SERVICE BULLETIN

Classification: AT96-003b	Reference: NTB96-009b	Date: June 5, 1996
------------------------------	--------------------------	-----------------------

RE4F04A AUTOMATIC TRANSMISSION (A/T) - WILL NOT SHIFT WHEN PLACED IN REVERSE

APPLIED VEHICLE(S):
1993-1996 Quest (V40)
1992-1994 Maxima SE (J30)
1995-1996 Maxima (A32)
1993-1996 Altima (U13)

Figure 1

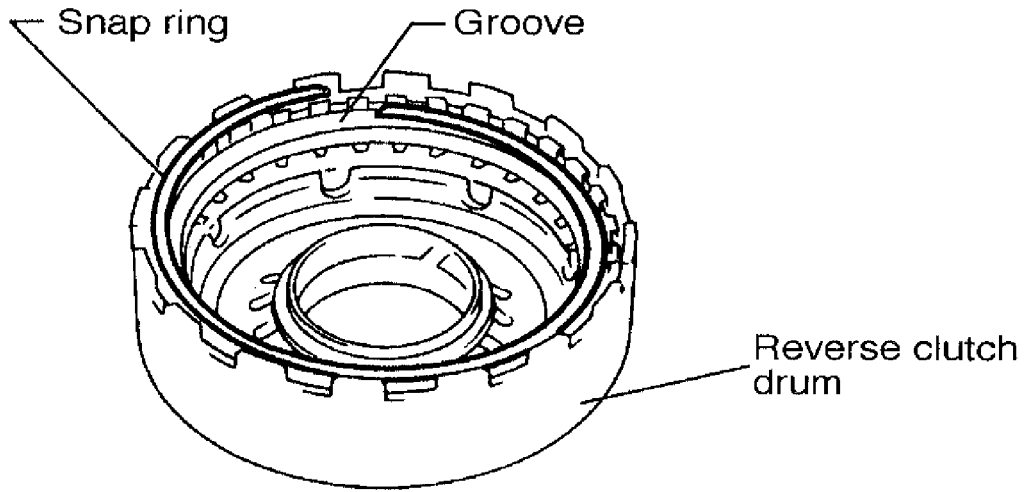
3. Perform a line pressure test using Kent-Moore J34301-C A/T pressure gauges. If the snap ring has popped out (refer to Figure 1), the line pressure in reverse will be low or zero.

4. If the line pressure is low or zero, remove the reverse clutch drum and inspect the snap ring and retaining groove. If the snap ring has popped out, replace the snap ring using the part number on the following page. If the reverse clutch inner drum retaining groove shows signs of wear, replace the reverse clutch drum using the part numbers listed on the following page.

The reverse clutch drum snap ring may pop out of the inner drum retaining groove to cause this incident. A countermeasure reverse clutch drum, snap ring, and 2 dish plates has been developed to resolve this incident.
